Date: JUN 07 2017
Symbol: EPC-DO: 17-196
LA-UR: 17-22189
Locates Action No.: N/A

Subject: Notification of Class 1 Permit Modification Facility Description Updates for the Technical Area 63 Transuranic Waste Facility Container Storage Unit, Los Alamos National Laboratory Hazardous Waste Facility Permit, EPA I.D. #NM0890010515 (NA/LA)

**Class 1 Permit Modification
Facility Description Updates for the
Technical Area 63 Transuranic Waste Facility
Container Storage Unit,
Los Alamos National Laboratory
Hazardous Waste Facility Permit**

DWG-102355-C55443-C-1017, *Retention Basin Foundation Plan*

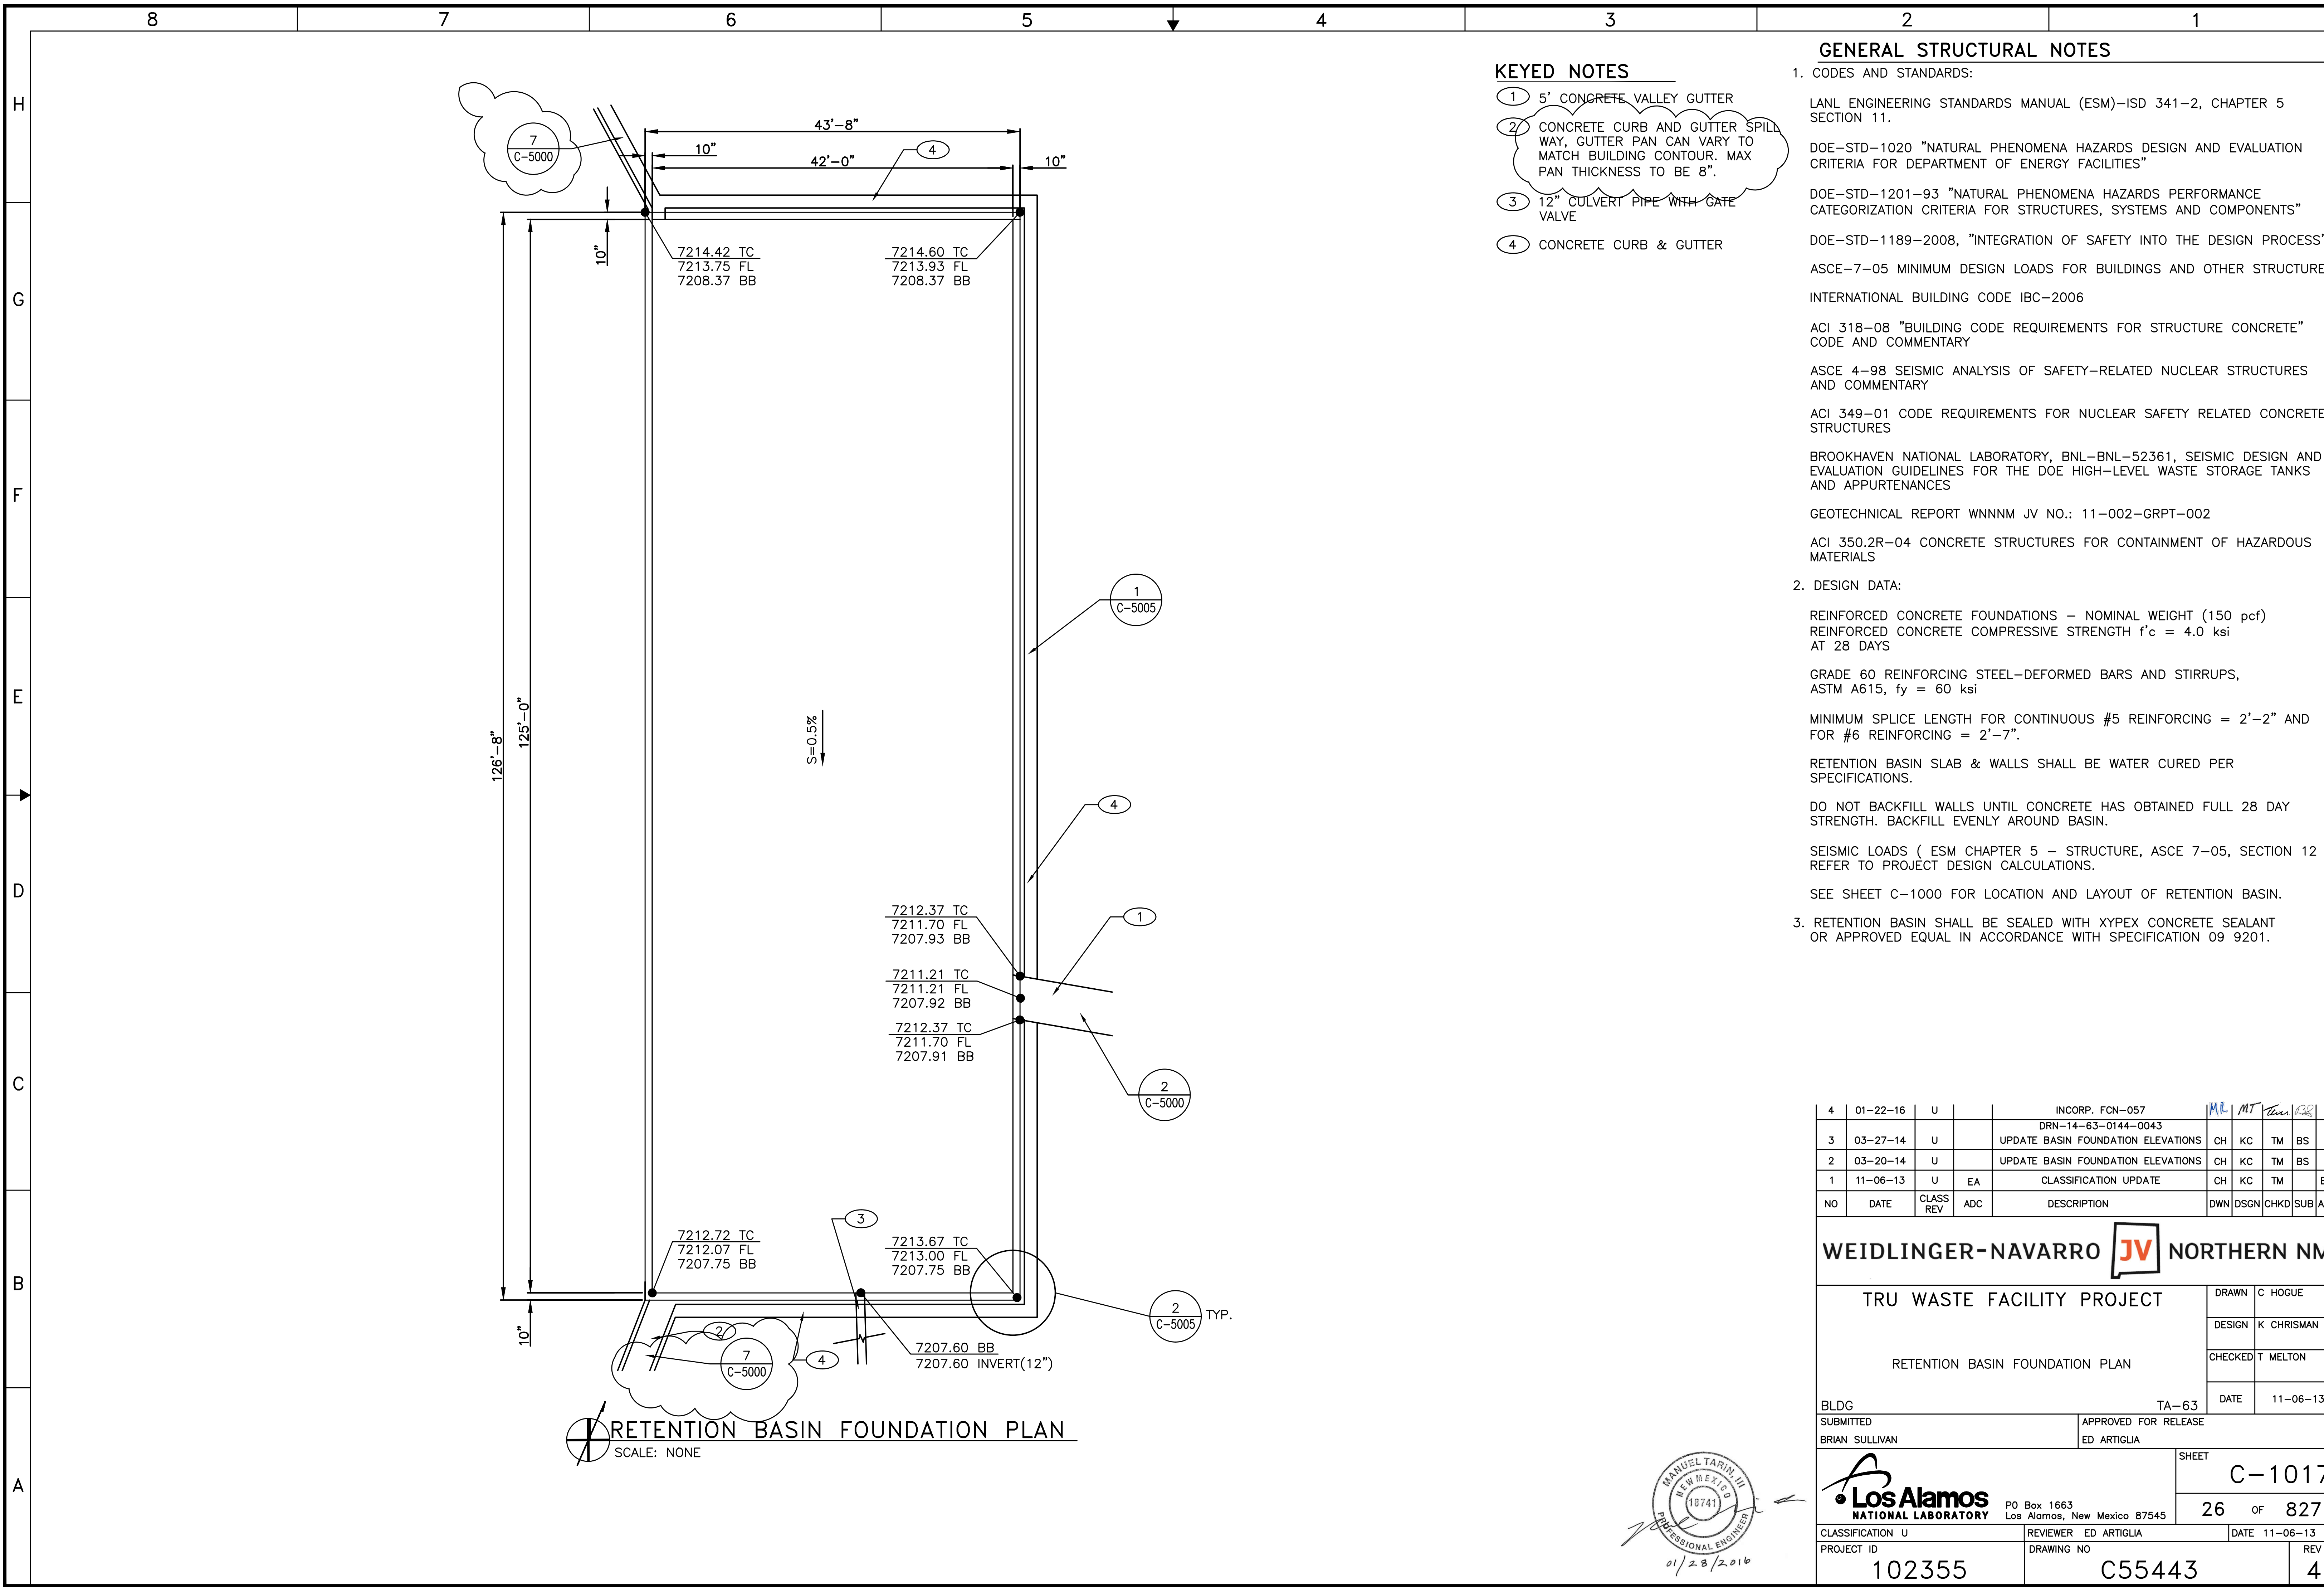
The discussion of the design capacity for the TA-63 TWF retention basin requires a text correction. The retention basin dimensions described in Permit Attachment A, *Unit Descriptions*, Section A.6.5, *Retention Basin*, were revised by the 2014 Permit modification (LANL, 2014) as the designed depth had been changed due to an alteration of the original slope of the retention basin floor. The total designed volume capacity of 137,450 gallons was not changed but the depth increase indicated a 1 foot freeboard rather than the 0.5 foot freeboard originally given in the discussion. The revised section contains a sentence that states: “The designed total retention basin volume also includes 1.0 ft. of freeboard, resulting in a total capacity of 137,450 gallons...” This revision did not address the 6 inch depth of the overflow curbing cut-out in the south west corner of the retention basin. Subtracting the depth of the

overflow cut-out corrects the freeboard height description to 0.5 feet and the sentence has now been altered to state that in this modification. This change does not affect the designed retention basin capacity. Attachment 1 of this document includes two figure drawings with the general plan of the retention basin and the construction detail showing the dimensions for the overflow. It also includes a photograph of the overflow curbing cutout and the text revision for Permit Section A.6.5.

MISCELLANEOUS DETAILS

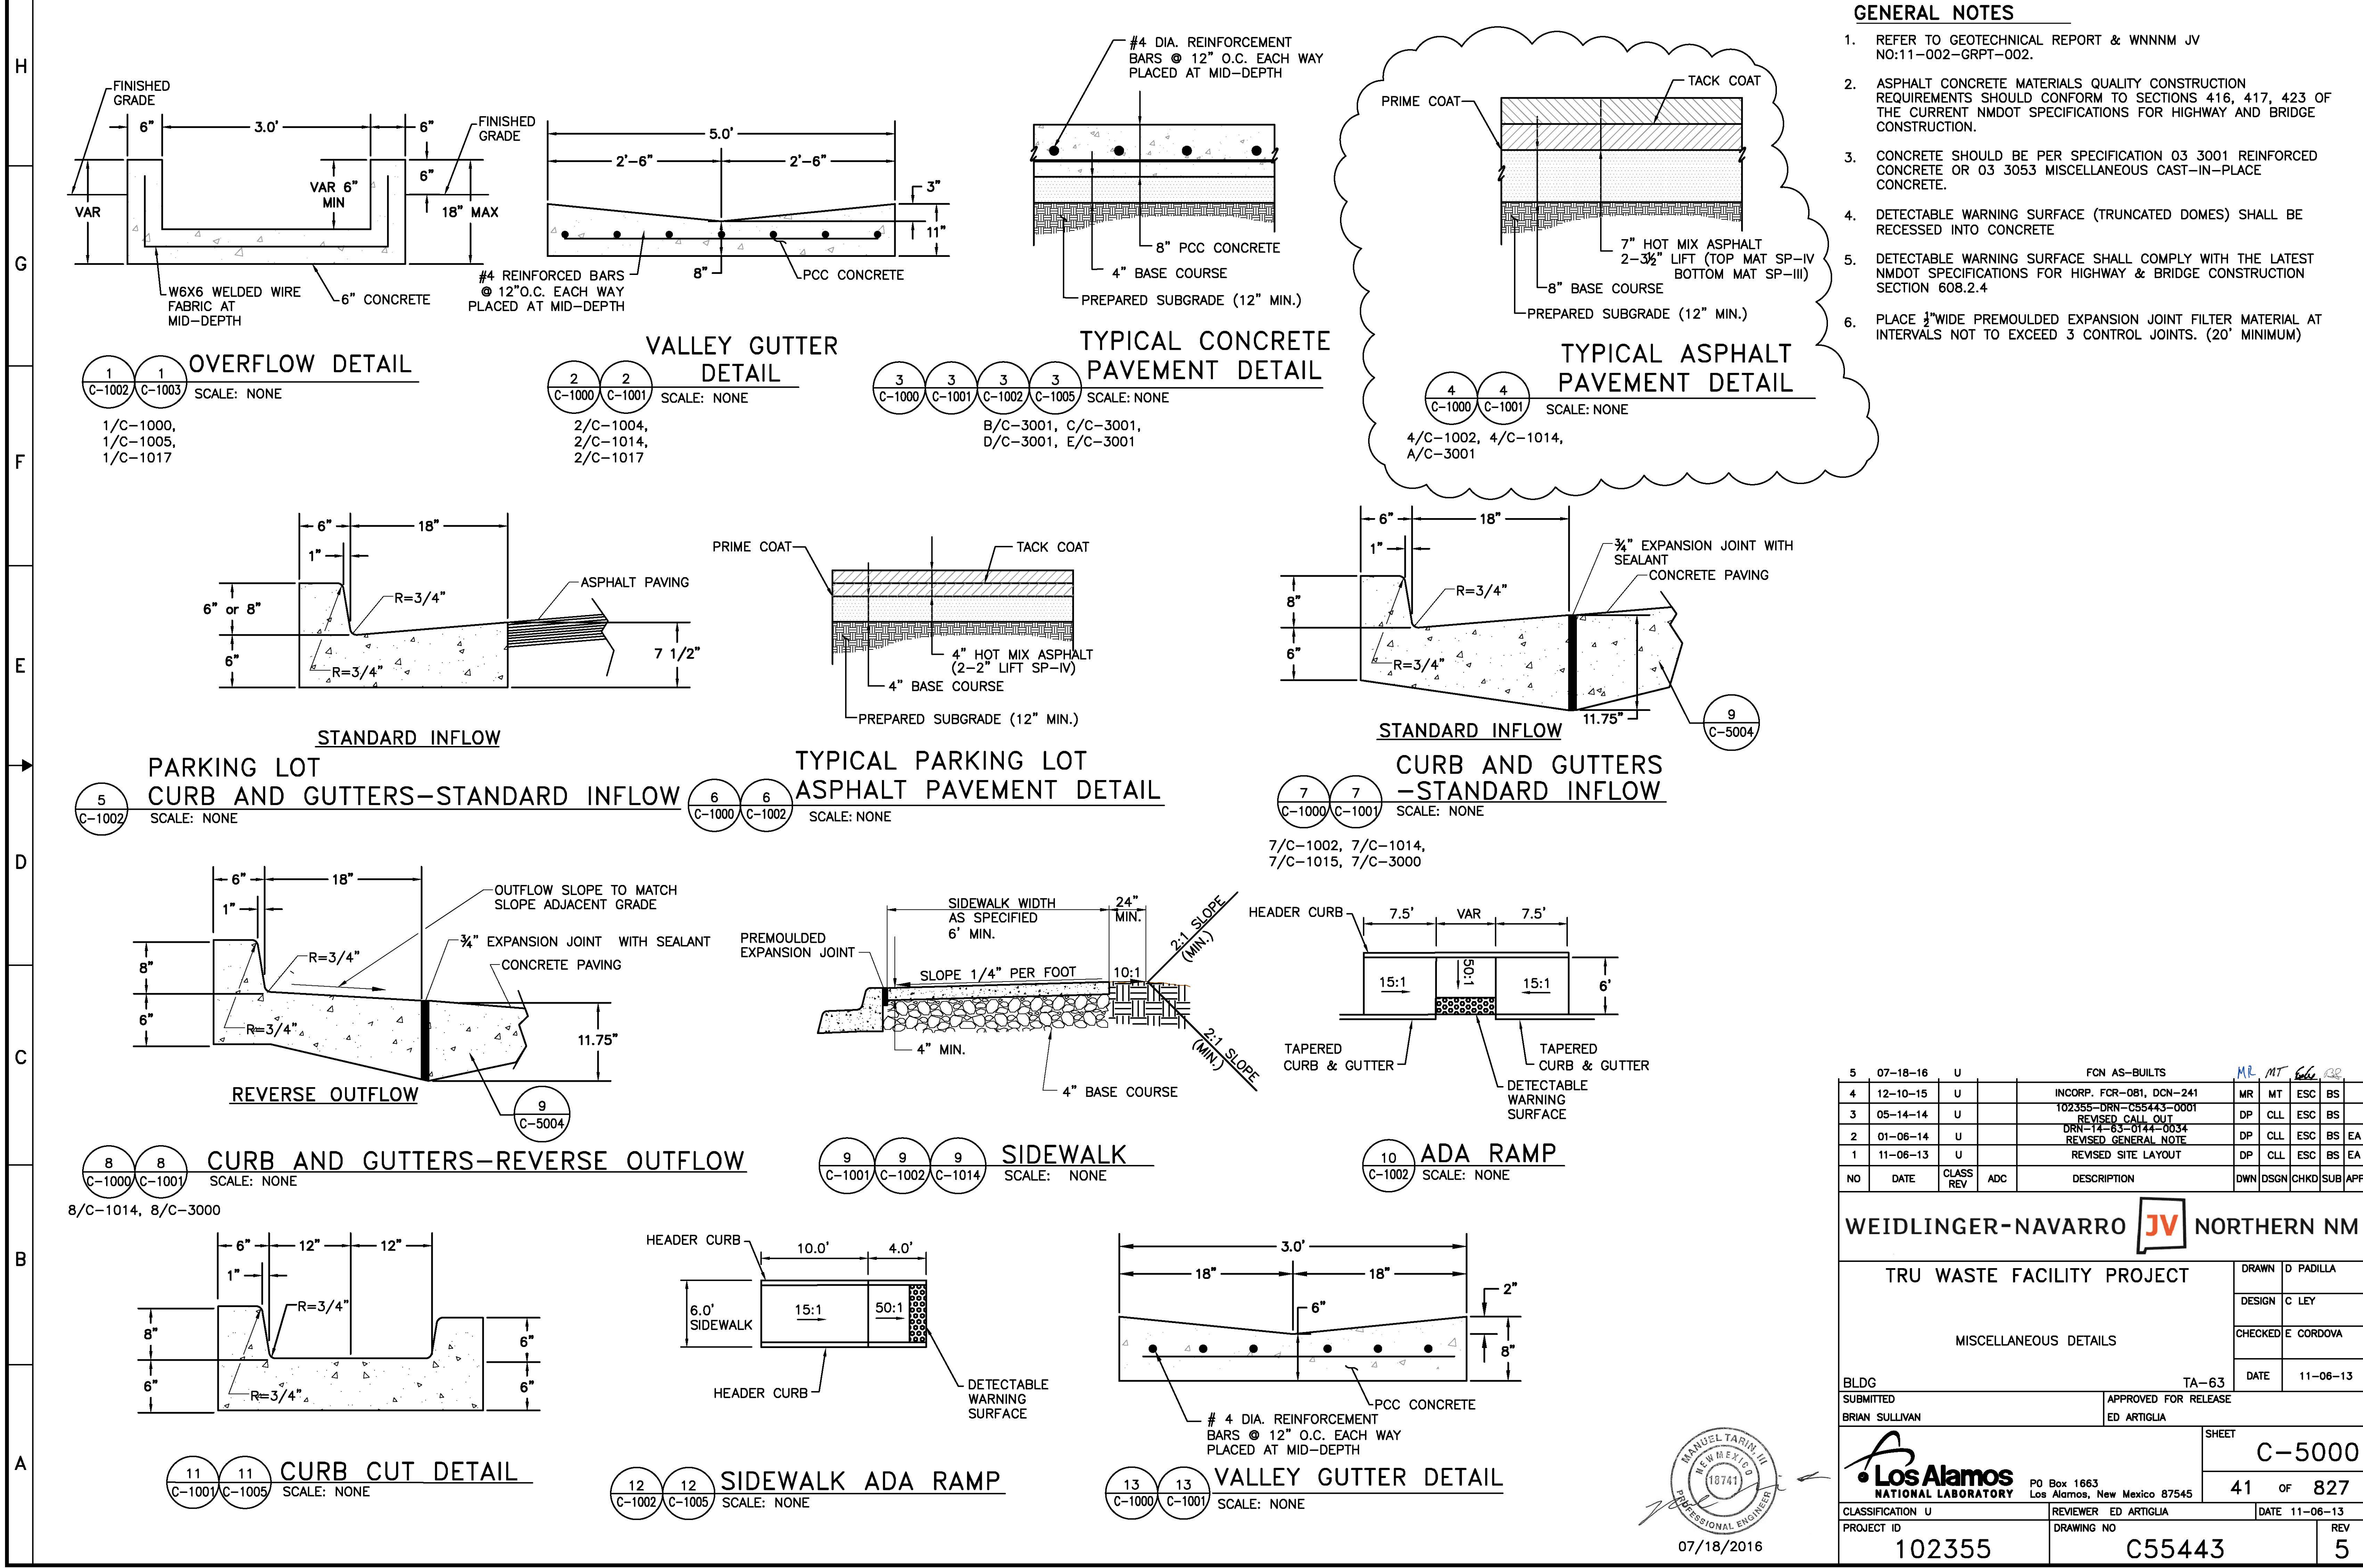
DWG-102355-C55443-C-5000, *Miscellaneous Details*
(See “Overflow Detail”)
